ON-SITE SEWAGE DISPOSAL SYSTEM HOWARD COUNTY HEALTH DEPARTMENT BUREAU OF ENVIRONMENTAL HEALTH

ADDRESS: 14914 Bushy Park Road PROPERTY OWNER: David & Sandy Trapani

TRENCHES:	Trench to be <u>2</u> feet wide. Inlet <u>10</u> feet below original grade. Bottom maximum depth <u>10</u> feet below original grade. Effective area begins at <u>4.5</u> feet below original grade. <u>5.5'</u> feet of stone below distribution pipe.
LOCATION:	
PURPOSE:	In support of building permit # B00148490 for proposed addition. Relocating septic tank to make room for addition. Call for inspection when ground is open, must abandon and collapse old septic tank.

DAVID & SANDY TRAPAWI
14914 Bushy Park Rd
Woodbine, MD

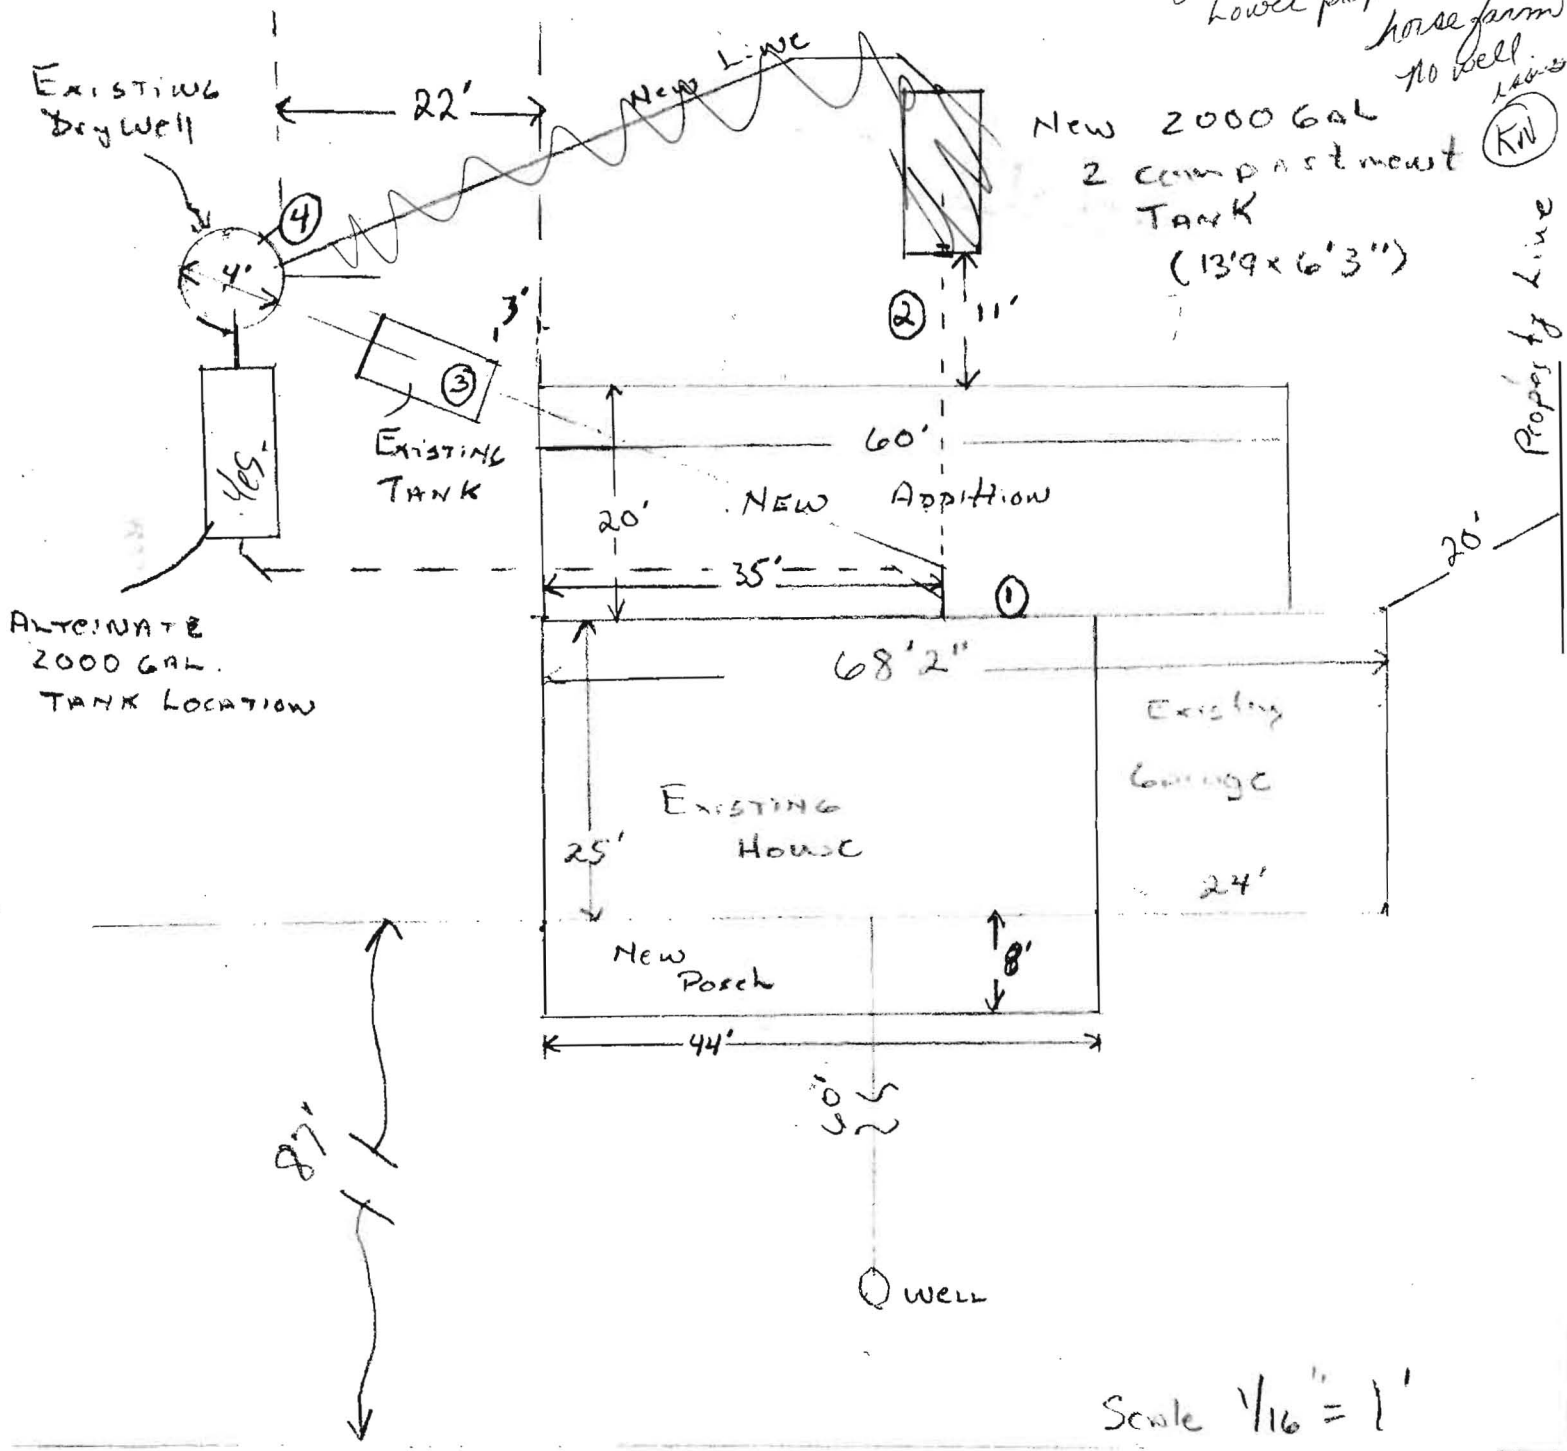
5/14/04 OFC MTG
 W/OWNER RE: PROPOSED
 1 BR ADD'N W/ 1 BR
 DELETION TO EX. 3BR HOUSE
 S.T. < 10' TO ADD'N
 D/W 28 YRS OLD

7
 ADVISED OWNER S.T.
 RELOCATION, ~~ADD~~
 EVAL OF SOILS @
 EX. D/W AND
 EVAL OF ~~EXIST.~~ TRENCH
 SATURATION
 REQ'D

OWNER MAY CONSIDER
 SYSTEM FOR EX. S.T.
 4-BR HOUSE

6/2/04
GIS - topo
shows gentle
ridge -
adj. properties
have wells in
front yards - upslope
lower properties -
horse farm
no well
